Clyde King Subdivision 2024 Addition

Preliminary Plat

**ITEM #4 - PRELIMINARY PLAT
CLYDE KING SUBDIVISION 2024 ADDITION**

KPB File No.	2024-115
Plat Committee Meeting:	November 18, 2024
Applicant / Owner:	Kenai Peninsula Seward Properties, LLC
Surveyor:	Jerry Johnson – Johnson Surveying
General Location:	Bear Creek

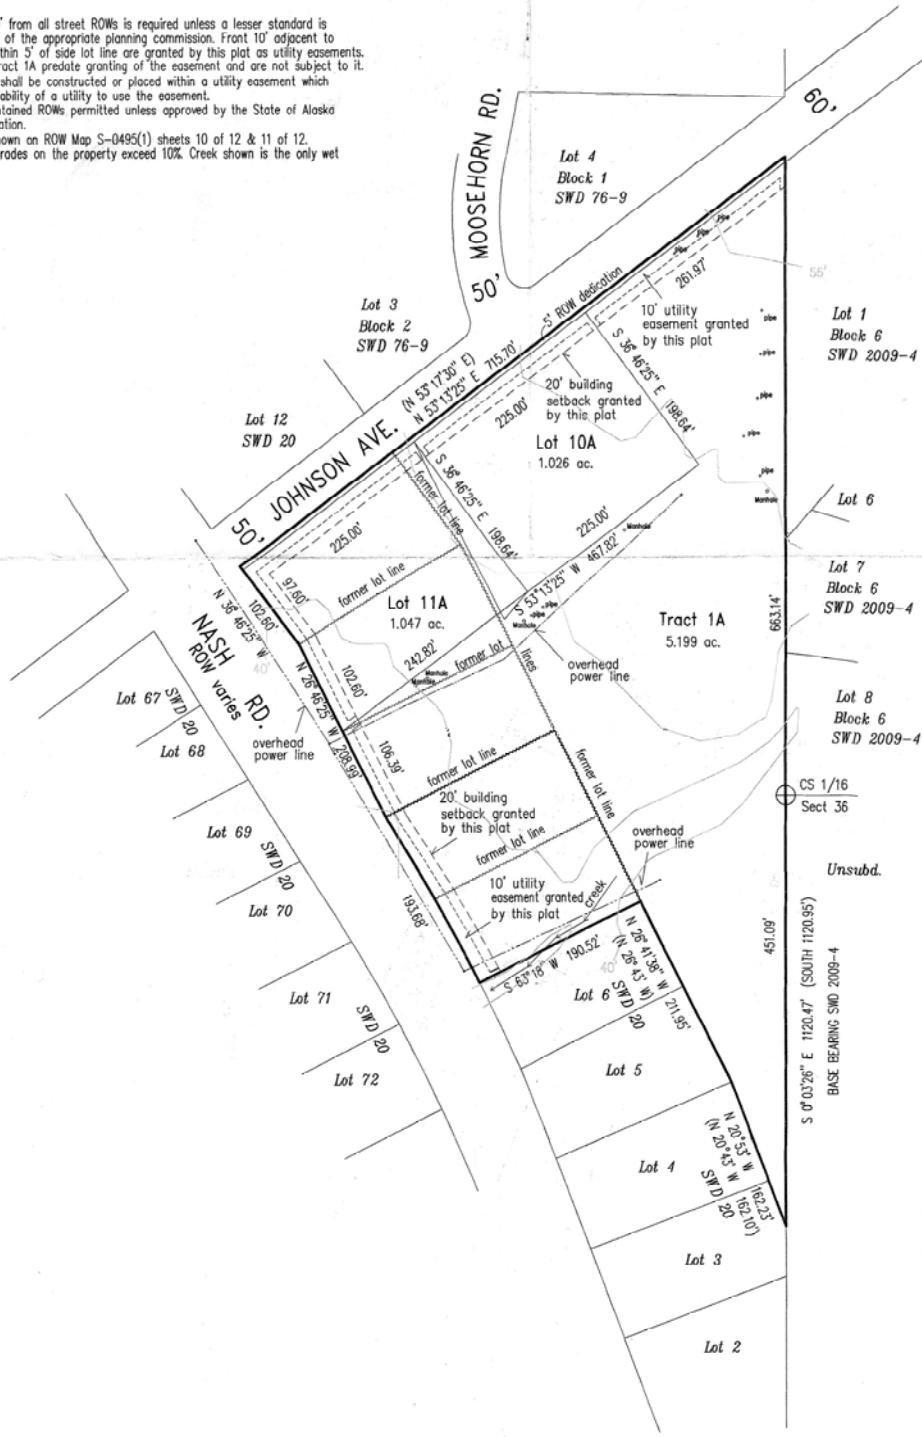
KPB Roads Dept. comments	Out of Jurisdiction: No Roads Director: Griebel, Scott Comments: No RSA comments.
SOA DOT comments	Missing curve data along Hash Road. (Reference Record of Survey 2004-1 SRD)

Per KPB Imagery, there are multiple structures located on the parent parcel. On the preliminary plat, septic pipes are depicted within the 10-foot utility easement, which pre-dates the granting of the easement.

Staff recommends: The surveyor to confirm if structures will encroach on proposed Lots 10A and 11A. Manhole labels and pipe labels to be removed from final unless within easement.

Staff recommends: The surveyor confirm source of the creek.

Per KPB Imagery, there are structures very close to the proposed common lot lines and possibly the east line of the plat. **Staff recommends:** *the surveyor confirms whether an encroachment affects the replat. If a permanent structure or structures cross a lot line, staff requests the encroachment be shown and a note be placed on the final plat to indicate that acceptance of the plat by the Borough does not indicate acceptance of any encroachments.*

Add KPB file no 2024-115 to the title block
 Correct the legal description within the title block, "Clyde King Subdivision Addition No. 1, SW 74-5.
 Add curve data to the front of the plat
 Add a Certificate of Acceptance for the 5' dedication along Johnson Ave
 There are some extra lines in Lot 10A that need cleaned up.

- D. A vicinity map, drawn to scale showing location of proposed subdivision, north arrow if different from plat orientation, township and range, section lines, roads, political boundaries, and prominent natural and manmade features, such as shorelines or streams;
Staff recommendation: *Adjust railroad tracks in section 34 to match KPB imagery; align more with airport instead of highway.*

- F. The location, width and name of existing and platted streets and public ways, railroad rights-of-way, easements, and travel ways existing and proposed, within the subdivision;
Staff recommendation: *Depict and add plat notes to reference right-of-way easements granted to City of Seward per documents recorded in Book 51R at Page 281 (CTP # 12) and Book 77 Page 954 (CTP # 13).*

Staff recommendation: Add lot 13 to parcel adjacent to the north. Legal description includes lot 12 and lot 13, SWD 20.

- J. Block and lot numbering per KPB 20.60.140, approximate dimensions and total numbers of proposed lots;
Staff recommendation: It appears that there are some additional lot lines drawn near the easterly side of Lot 11A. Please correct.
- N. Apparent encroachments, with a statement indicating how the encroachments will be resolved prior to final plat approval;
Staff recommendation: Structures may encroach into proposed Lot 10A. Surveyor to confirm.
